## Product Change Notice #20201005

PCN Issue Date: 05/October/2020	Effective Date: 01/January/2021
Subject: Change in package assembly lead-frame type from LOC to Non-LOC type	
PCN Type: <input type="checkbox"/> Discontinuation <input type="checkbox"/> Foundry <input checked="" type="checkbox"/> Assembly <input type="checkbox"/> Test <input type="checkbox"/> Datasheet <input type="checkbox"/> Other	
Description of Changes	Change in TSOP package lead-frame type from Lead-On-Chip (LOC) to conventional Non-LOC (Chip on Lead) type package assembly
Reason for Change	The Vendor for LOC type, Innox has planned to stop the production of LOC type material. In order to continue support our valuable customer, Alliance Memory has qualified conventional non-LOC type.
Traceability Guidelines	Materials Starting from Date Code YYWW 2101 (Year 2021, Work Week 01) will be from new lead frame type
Reliability & Quality	There is no change to Package-Outer-Dimensions, Functional-Behaviour, Electrical-Performance, Quality and Reliability of product.

### Affected Products

**Appendix1:** Description of Change

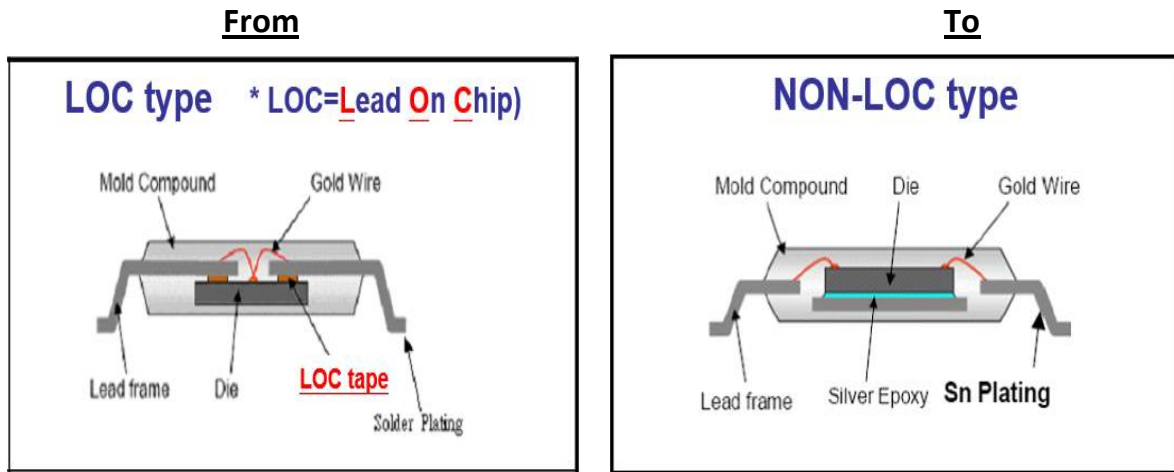
This PCN is to notify a change in package lead frame type from LOC type to Non-LOC type as lead frame supplier announced supply discontinuation of LOC type materials. To ensure supply continuity and minimal disruption to supply chain, Alliance Memory Inc had qualified the change to ensure no change in Form-Fit-Function of the affected part numbers by performing all due diligence standard qualifications. This Change shall be effective from 01 January 2021 - Year-Year-Work-Week (YYWW) 2101
